IMPORTANT SAFETY RECALL

- Your vehicle is involved in GM recall 15166.
- Install the enclosed label or schedule an appointment.
- This service will be performed for you at **no charge**.

GM Recall #15166

Vehicle Certification Label Installation Instructions

4152227

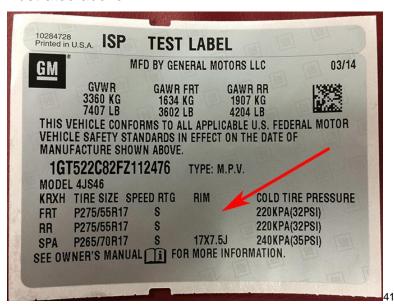
Locate the Vehicle Certification Label on the lower section of the driver's door jamb as illustrated above.

- 3. The original label may be blank under the "RIM" column, or have information hand written in. If the label is hand written, you may remove the writing with isopropyl alcohol (rubbing alcohol).
- 4. The original label must be clean and dry before installing the overlay label.

4152349

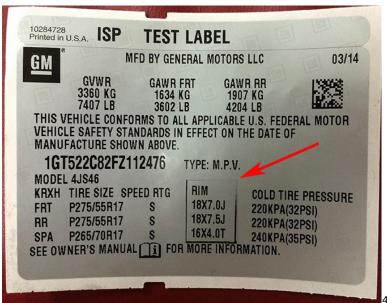
Locate the overlay label included with these instructions. Remove the label from the backing by folding the backing paper as shown above.

- 6. Apply the overlay label in the location shown above. Assure the label is properly positioned before allowing contact with the original label. The adhesive used is very aggressive and will not allow repositioning once the label is applied.
- 7. Close the driver's door.
